UNITED STATES PATENT AND TRADEMARK OFFICE

APPLICATION NO.	FILING DATE	FIRST NAMED INVENTOR	ATTORNEY DOCKET NO.	CONFIRMATION NO.
10/657,699	09/09/2003	Filiep Vanthourmout	KOB	8755
7590	07/14/2005		EXAMINER	
James C. Wray Suite 300 1493 Chain Bridge Road McLean, VA 22101			SUTTON, ANDREW W	
		ART UNIT	PAPER NUMBER	
			3765

Office Action Summary	Application No.	Applicant(s)	
	10/657,699	VANTHOURNOUT ET AL.	
Examiner	Art Unit		
Andrew W. Sutton	3765

DETAILED ACTION

FIG. 10

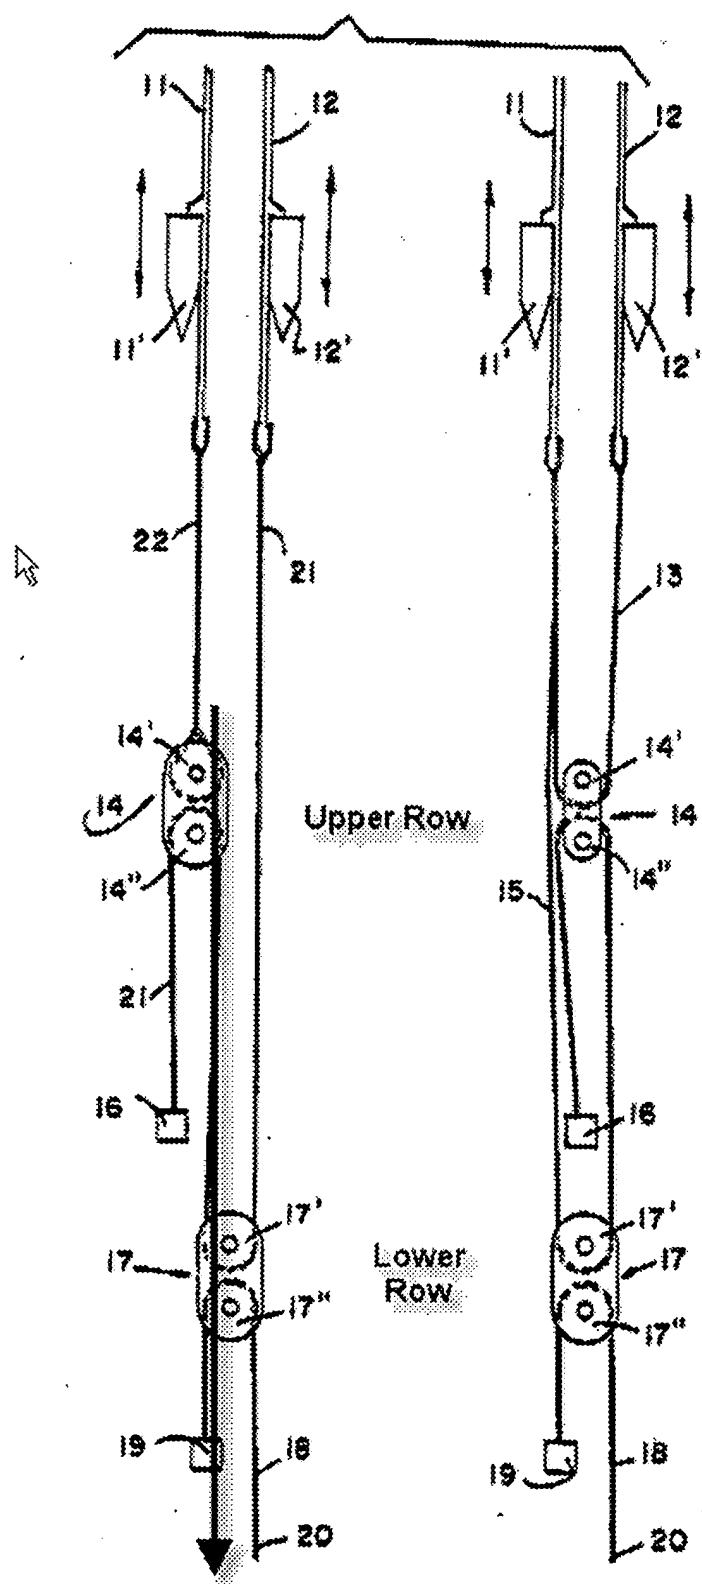
Claims 1-2 and 6-8 are rejected under 35 U.S.C. 102(b) as being anticipated by Derudder (US 5,139,052). Derudder illustrates (Figure 10) a shed forming device comprising two sets of hooks 11 and 12 operating in conjunction with a pulley wherein the complementary hooks 11 are operating in conjunction with one pulley 14, and a number of first pulleys 14 of one or more sets of hooks 11 are provided in an upper row, and a number of second pulleys 17 of one or more second sets of hooks 12 are provided in a lower row.

As to claim 2, Derudder illustrates (Fig. 10 and 11) first set of hooks 11 operating in conjunctions with the first pulley 14 in the upper row and hooks 12 operating in conjunctions with the second pulley 17 in the lower row. From the illustration below you can see that pulleys 14 and 17 would overlap each other when projected on the horizontal plane downward.

As to claim 6, Derudder illustrates (Fig. 10) a single lifting element 11' to lift hooks 11 upon selection.
